Department of Transportation

MEMORANDUM

SUBJECT: ZC Case No. 20-08D – Howard University Campus Plan Further Processing

Figure 1 | Proposed Site Circulation

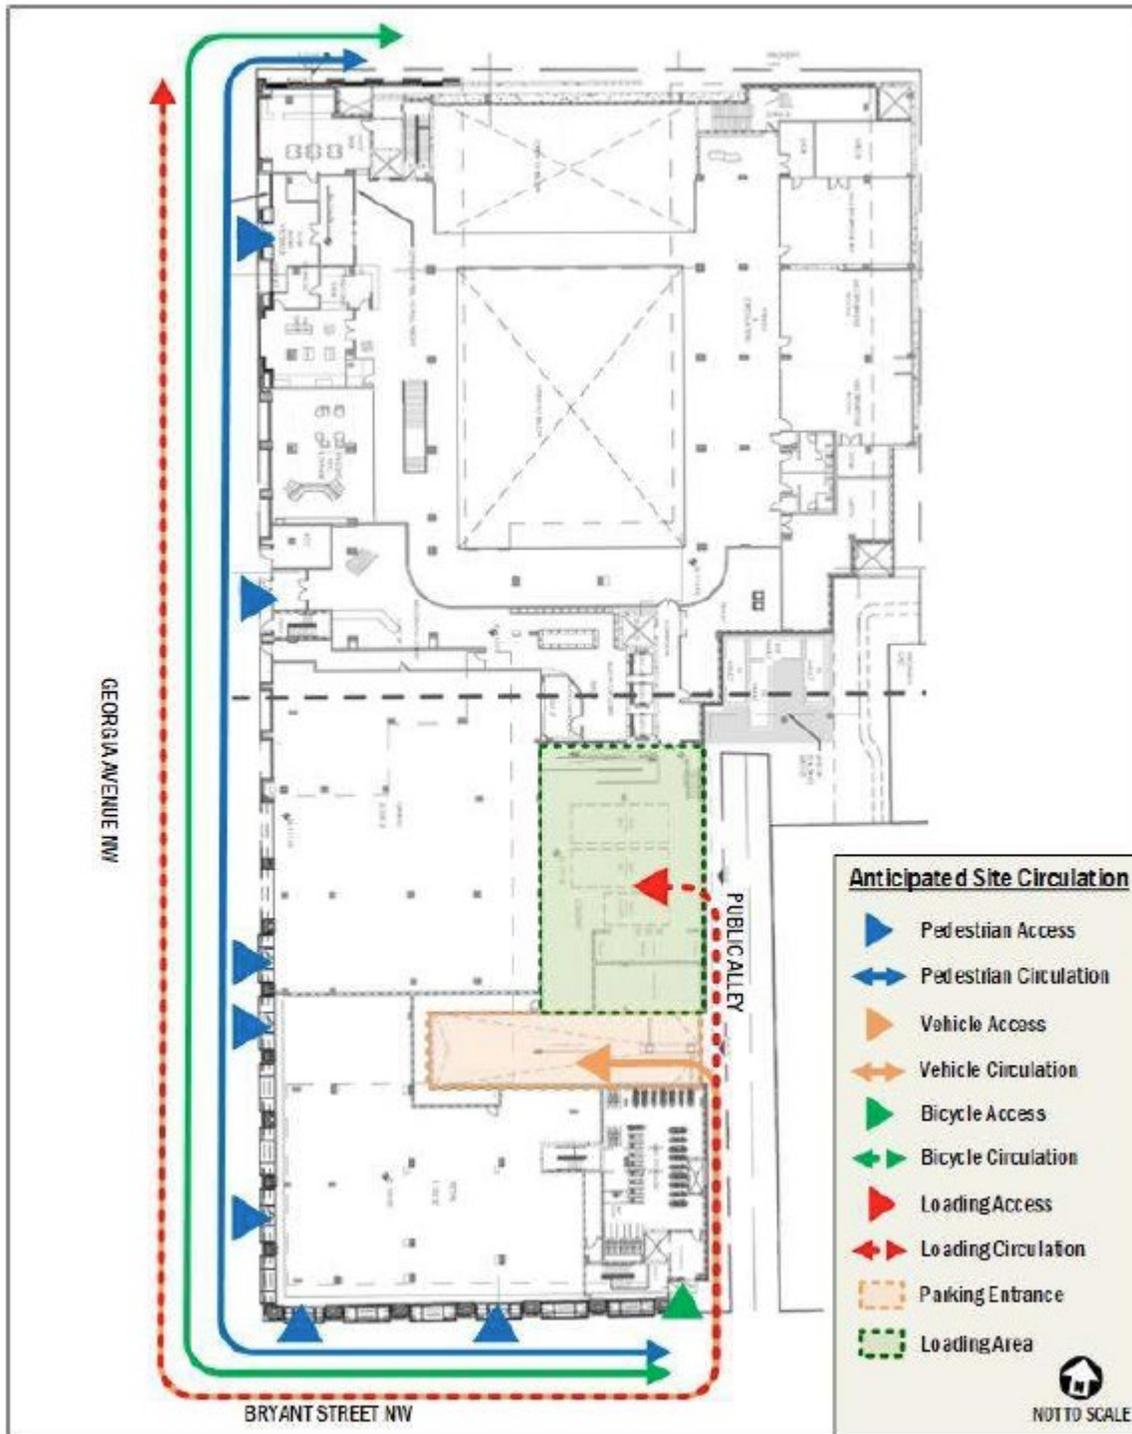
Per the approved Campus Plan, the site will be accessed by vehicles through from a rear public alley connecting to Bryant Street NW. The alley will be widened from 15 to 20 feet in width, and an existing curb cut immediately to the west of the alley will be closed.

Pedestrian access is also mainly provided from Georgia Avenue for the residential lobby, dining, and fitness center, while ground-floor retail spaces will have entrances on both Georgia Avenue and Bryant Street NW. Bicycle access is planned through the southern building frontage, leading to a secure, long-term bicycle parking room situated in the building's southern section. Figure 1, below shows the proposed site circulation.

Per Title 11 of the *District of Columbia Municipal Regulations (DCMR)*, Subtitle C § 901.1, residential properties with more than 50 units are required to provide one (1) loading berth and one (1) 20-foot delivery space. The project proposes to meet the zoning requirements and guidance established in the approved Campus Plan by providing a two (2) 30-foot berths and one (1) 20-foot service/delivery space in the new building.

Figure 4 | Existing, Planned, and Proposed Bicycle Facilities

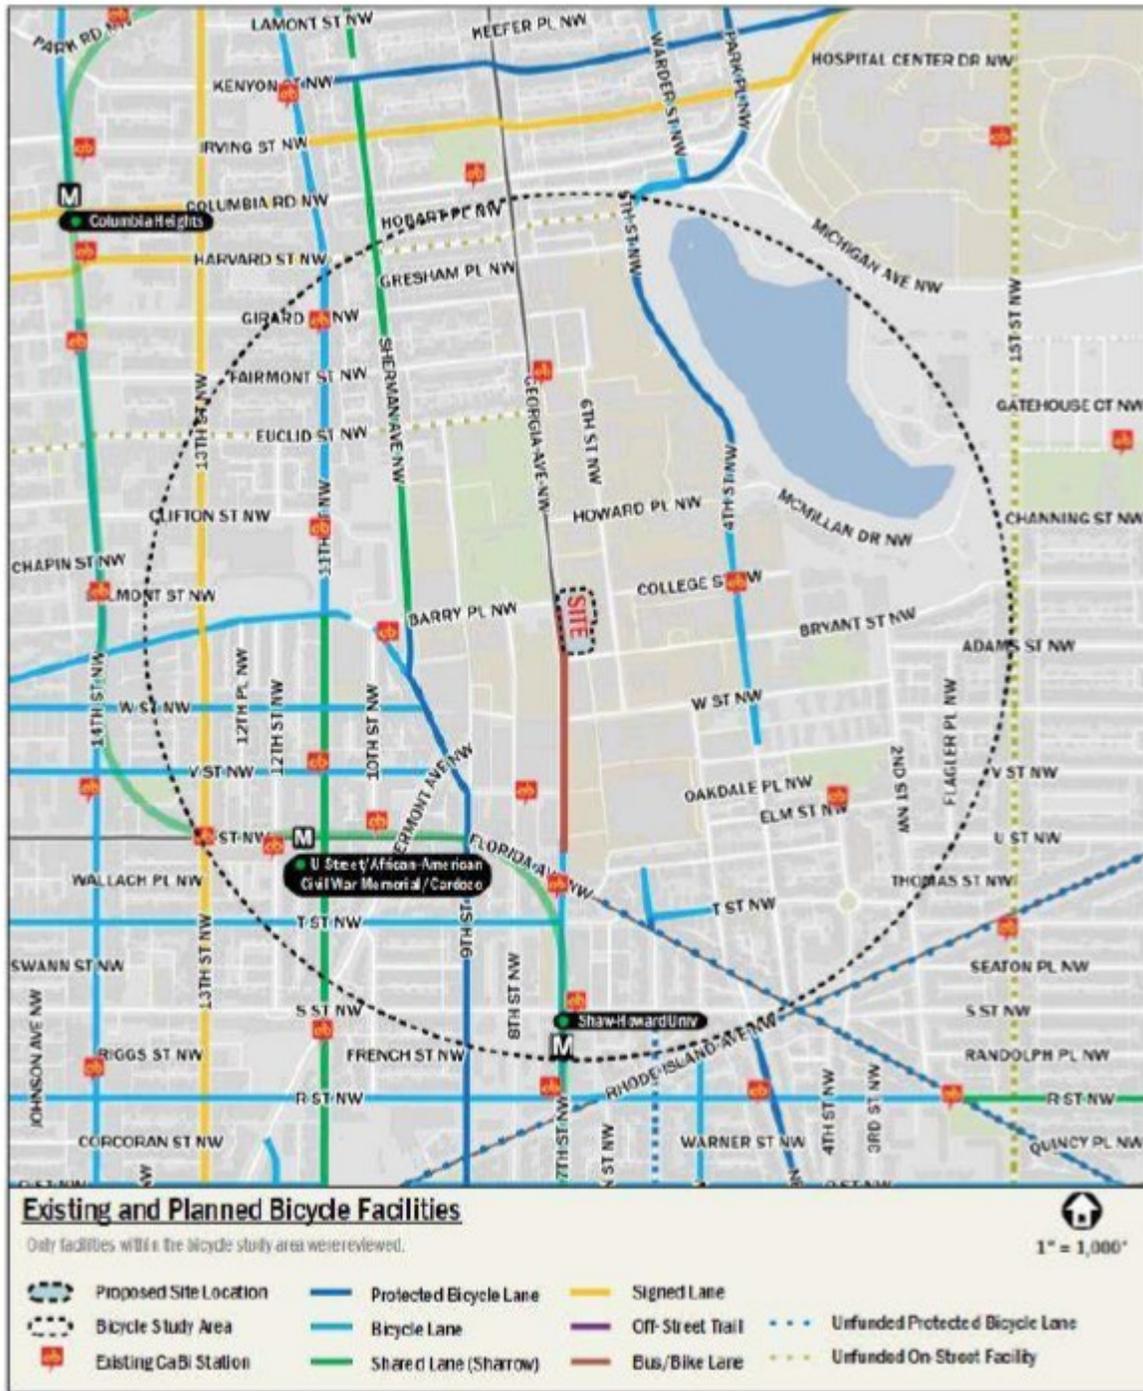
As shown in Figure 4, below, there are multiple bicycle lanes within ½ mile of the site. There are multiple Capital Bikeshare station located near the site.

Figure 6 | Curbside Designations

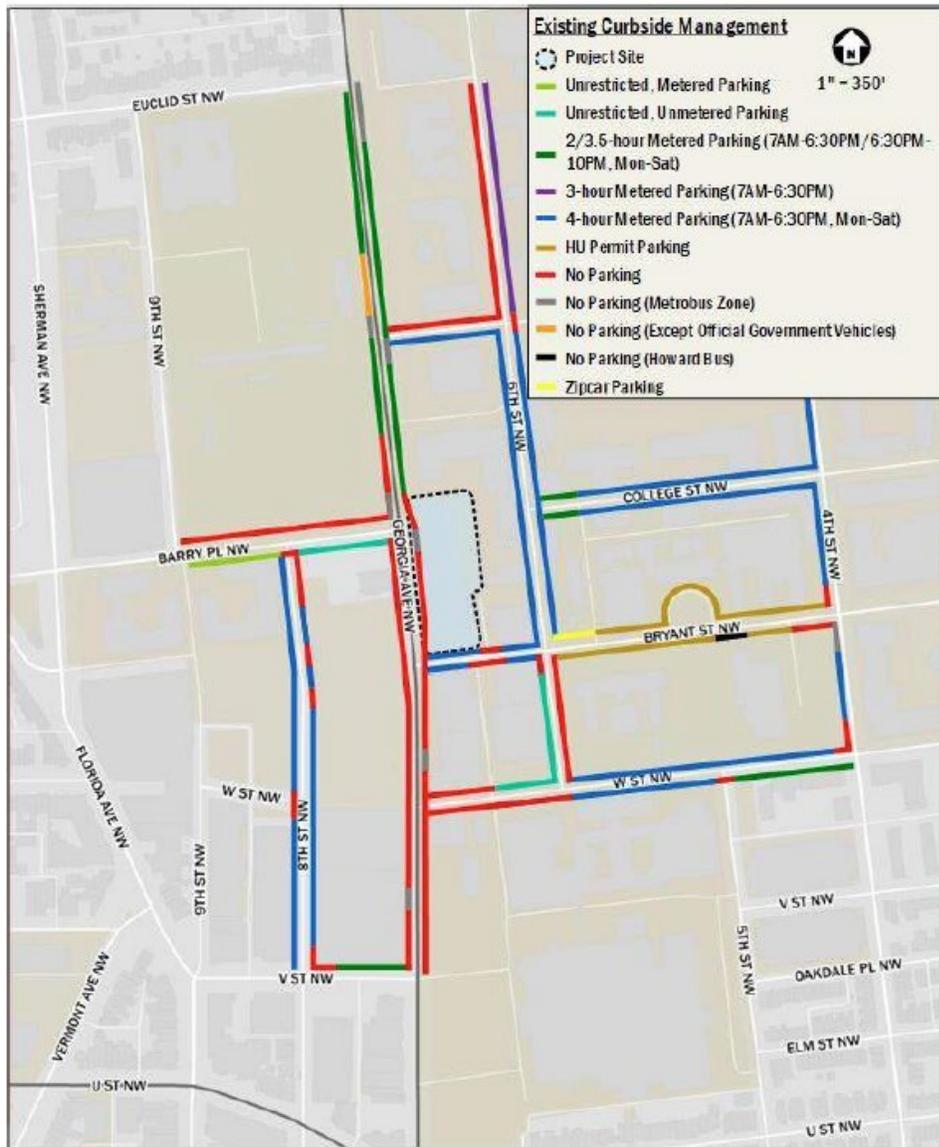
Curbside designations around the site are shown in Figure 6, below. The curbside designation on the site’s Georgia Avenue frontage are signed No Parking, while the Bryant Street frontage to the south is mainly four-hour metered parking. There is additional metered parking on streets to the north and east of the site.

The Applicant has not proposed any changes to the curbside designations with this project. DDOT is generally supportive of this concept; however, if any changes area proposed, a detailed curbside and signage plan must be submitted during public space permitting for review and approval by CMD. At that time, the plan may be refined by CMD, and the exact signage placards would be determined. If multi-space meters are required by CMD, these would be at the Applicant’s expense.
